Comments from the  
SNS Cryostat Design Review --  
11 - 12 February 2010

Tom Peterson, Fermilab  
15 February 2010

# SNS vs TTF cryomodule

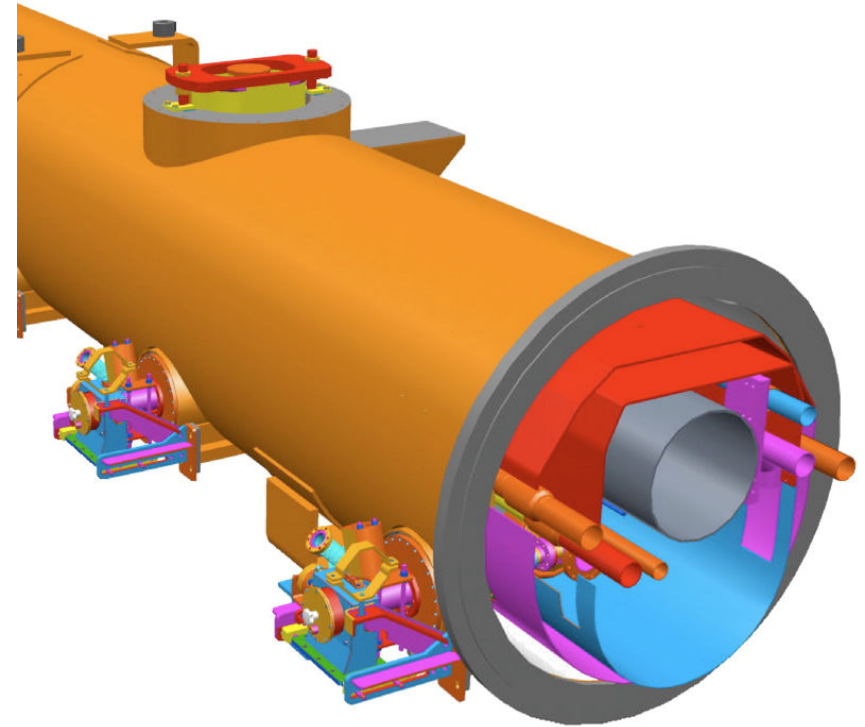
SNS (like CEBAF):  
self-contained vacuum vessel

TTF: vacuum vessel string.  
End boxes and bellows  
would become part of  
vacuum/pressure closure

- We like the use of the vacuum vessel as the pressure boundary
  - However, it would be more difficult for our TTF-style cryomodule
- Venting from vacuum vessel requires accommodating flow around thermal shields with possible plugging from MLI
- Code approved reliefs are required for vacuum vessel in order to meet code
  - A code case allowing non-UV stamped reliefs is up for consideration
- Oak Ridge has an ASME code vessel expert (John Swezy) who has provided help with interpretation of the code and code cases
- SNS also called upon a National Fire Protection Code expert to provide advice regarding whether NFPA 68: “Standard on Explosion Protection by Deflagration Venting” applies to the vacuum vessel.
  - The answer is NO
